PRODUCT UPDATE

Number 15

300A Series Motors

Motor Improvements

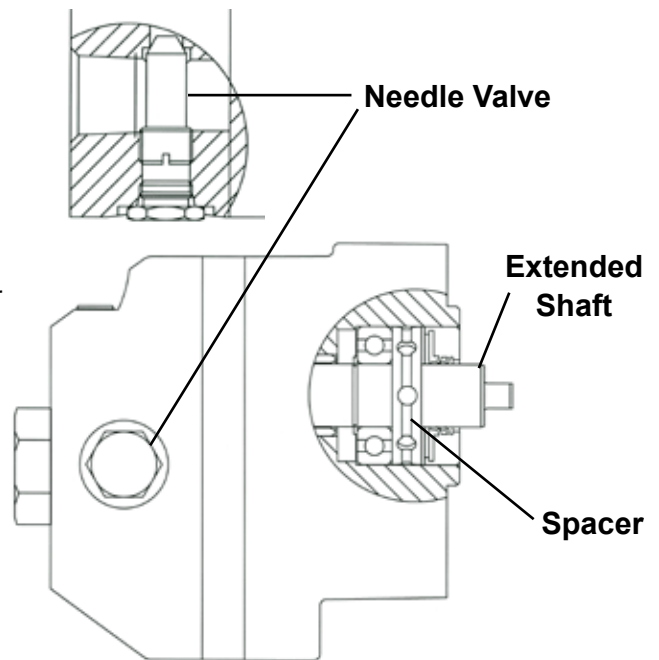
- ✓ The extended motor shaft eliminates the coupler (BAC-76-HYD) between the motor and pump shafts.
- ✓ A perforated spacer has been added between the shaft seal and bearing. The spacer improves oil flow to the seal reducing seal temperature and improving life.
- ✓ The high pressure lip seal and seal support spacer are standard in these motors.
- ✓ The needle valve is submerged in the casting and covered by a hex cap with o-ring seal to prevent leakage.
- ✓ The motor bolts attach from the pump side for easier installation and service. The bolts install through the mounting frame motor flange and thread into the motor drive plate. The "A" motor may be installed on older pumps by drilling the threads out of the four motor mount holes on the pump frame with a 3/8" drill.
